Access Compliance Report Public Rights-of-Way (Curb Ramps)

Main Street: BELLWOOD_RD Cross Street: BRIMHALL_DR Location: NW

ADA ID: RPRK211207135636 Ramp Type: Type 1 - Perpendicular Diagonal Initial Pass/Fail: Fail Overall Compliance: No Severity Score: 0

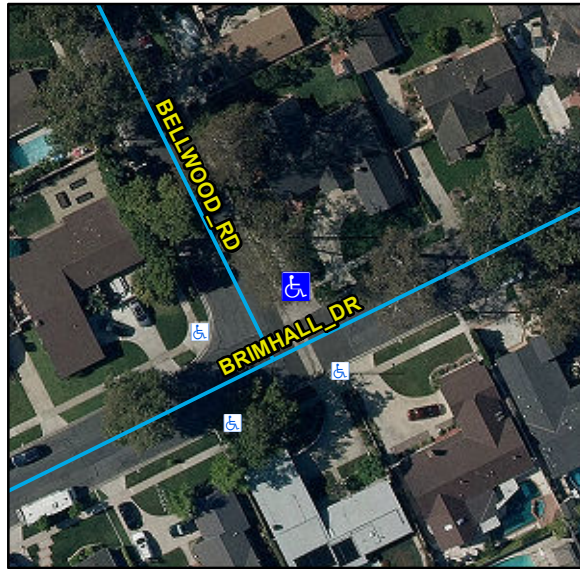
R304.2.2, R204.3, STD 1115

Remove & Replace Curb Ramp With Two New Directional Ramps or Equivalent.
